Eddy Building – Detached Addition : Addendum #2

ADDENDUM #2:

This Addendum No. 2 forms a part of the Contract Documents and modifies the original Drawings and Specifications dated September 6, 2024, as noted below. Acknowledge receipt of this addendum in the space provided on the Bid Form. Failure to do so may subject bidder to disqualification.

NEW PROJECT FOR
NC DEPT. OF AGRICULTURE & CONSUMER SCIENCES
SCO ID#: 22-24471-02A
EADDY BUILDING DETACHED ADDITION
4300 REEDY CREEK RD., RALEIGH, NC 27607

3 SECTION
3/4" = 1'-0"

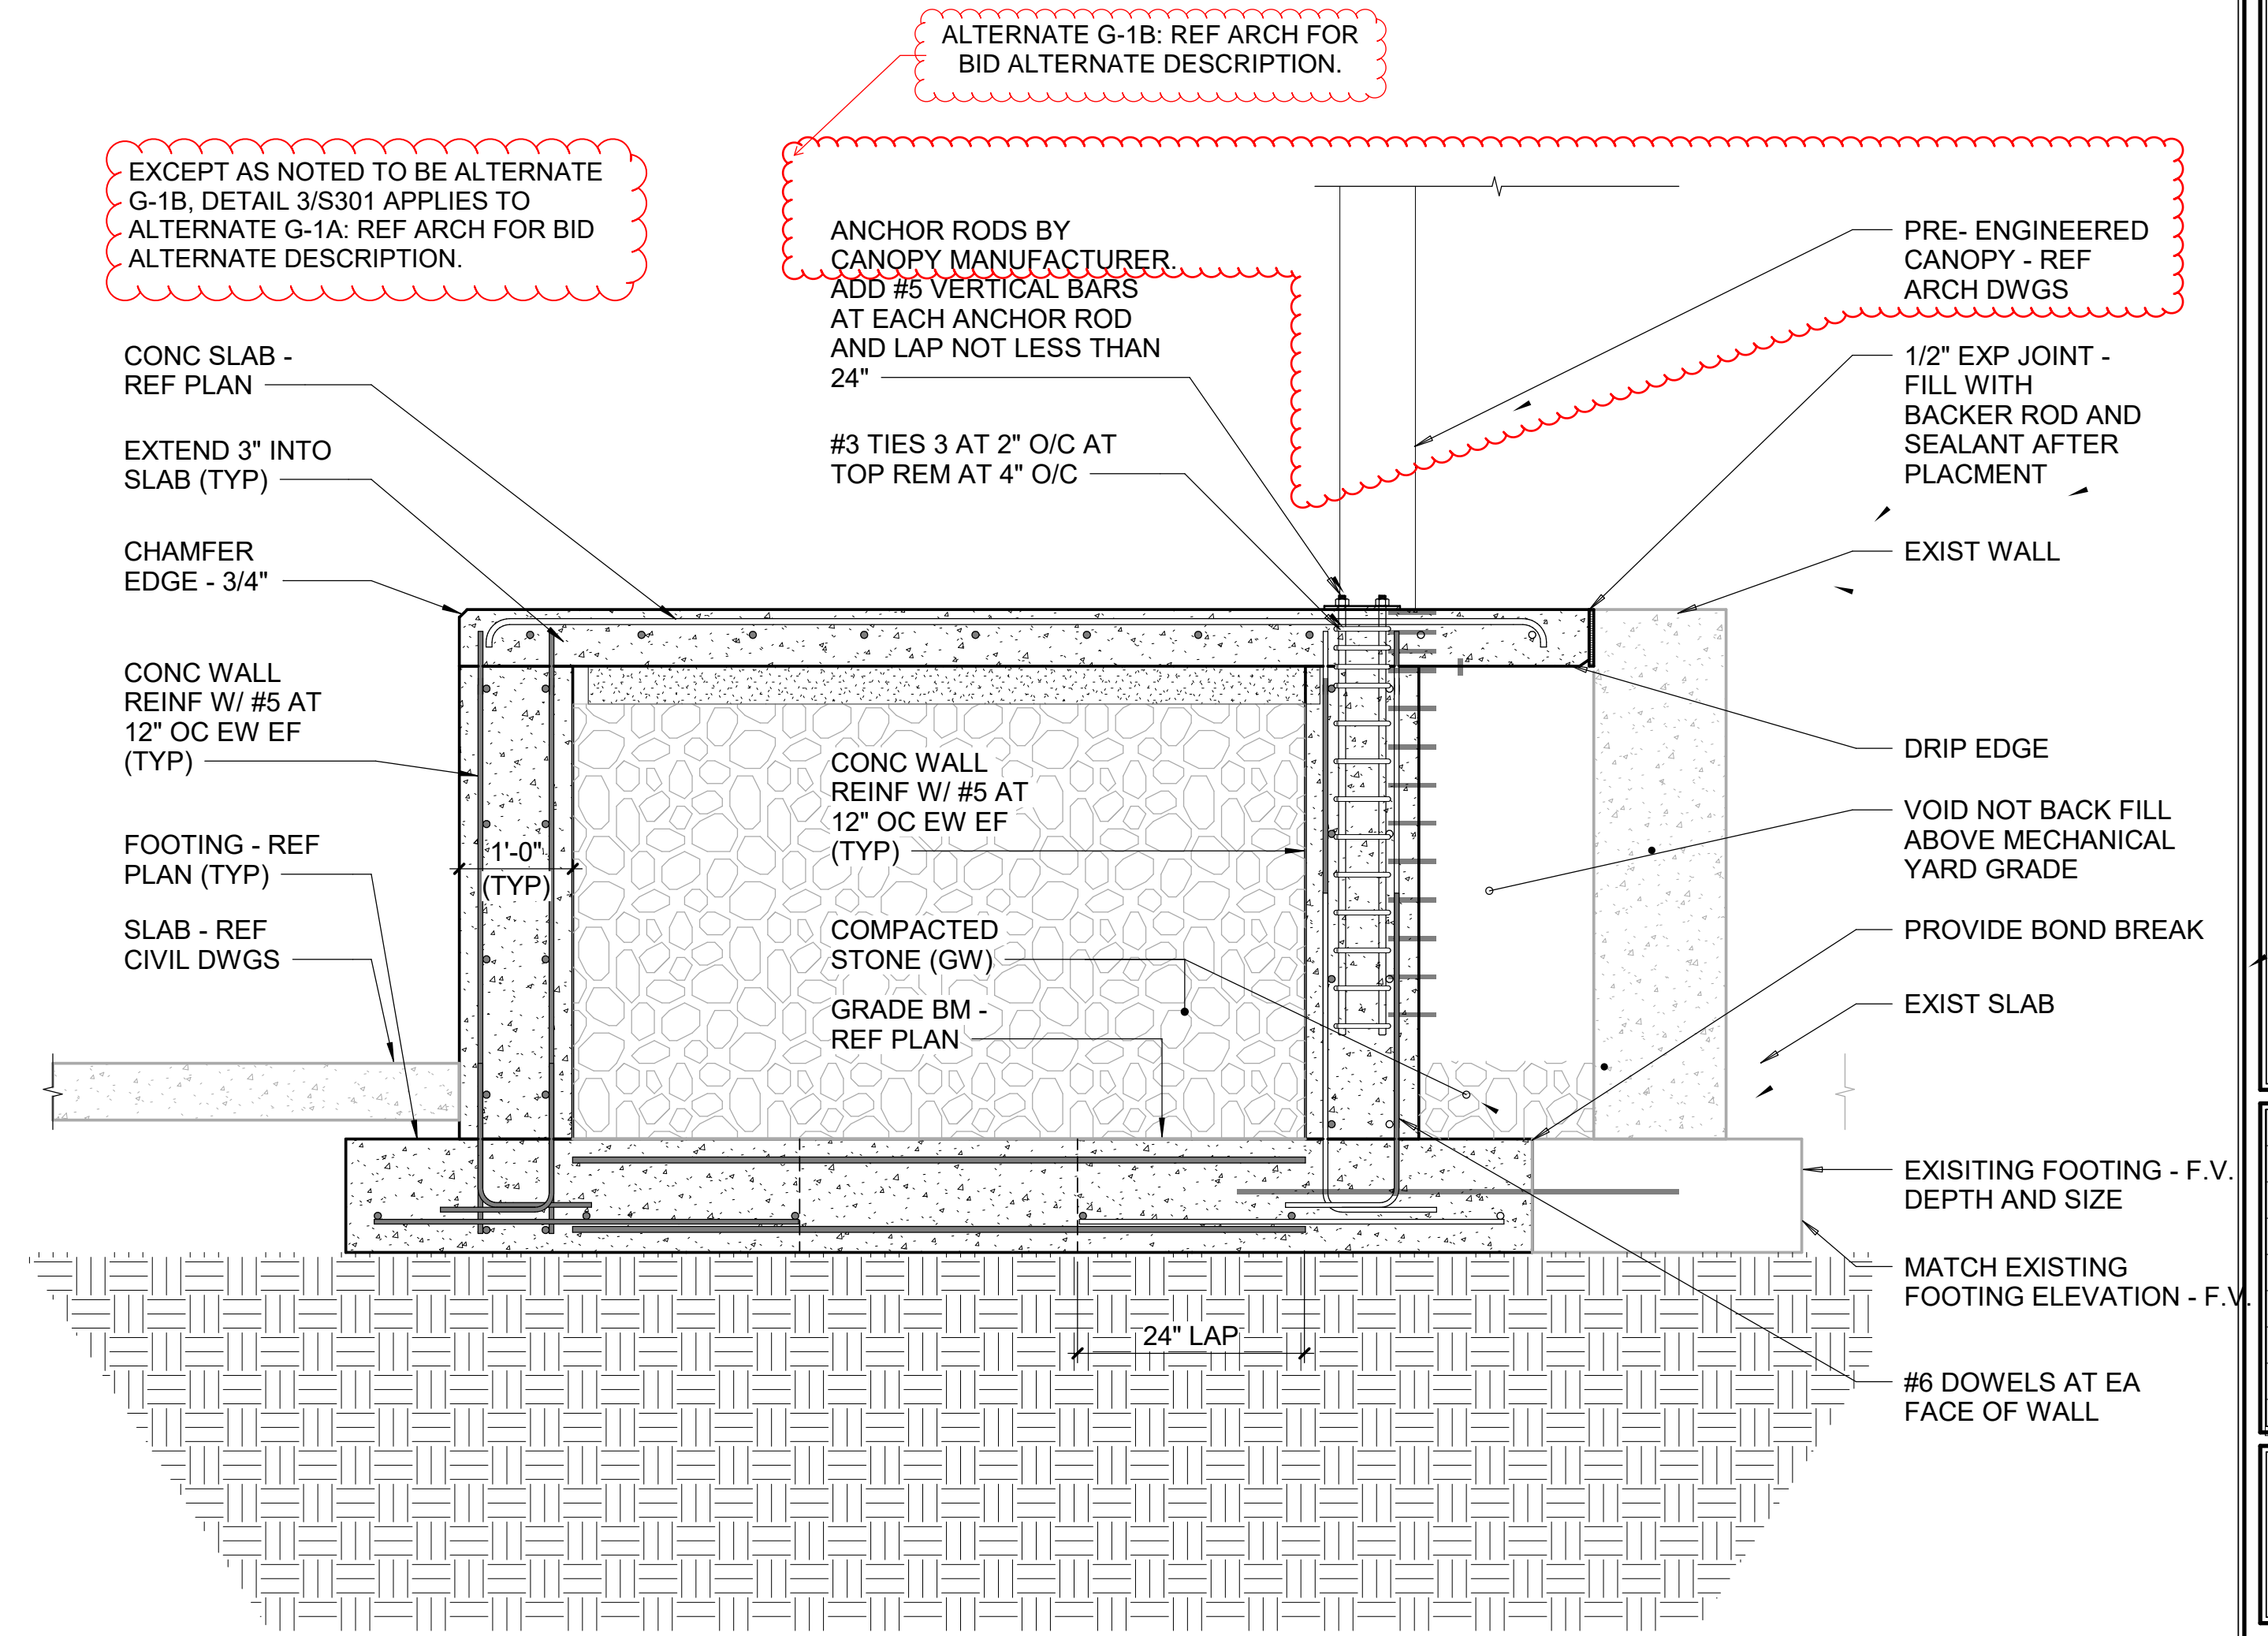
4. Need some clarification on the Alternate Platform. S112 – Note 6: Pre-mfg. galv steel platform 10x6' - S301 – Shows a concrete platform. Can you clarify this platform – steel or concrete?

- o RESPONSE: Key Note 6 on S-112 is calling out the manufactured galvanized steel platform landing at the top of the lift. This steel platform is interior to the building. Section 3/S-301 is a section through the exterior elevated walkway that is concrete (see section tag on S-112 for where this detail is taken).
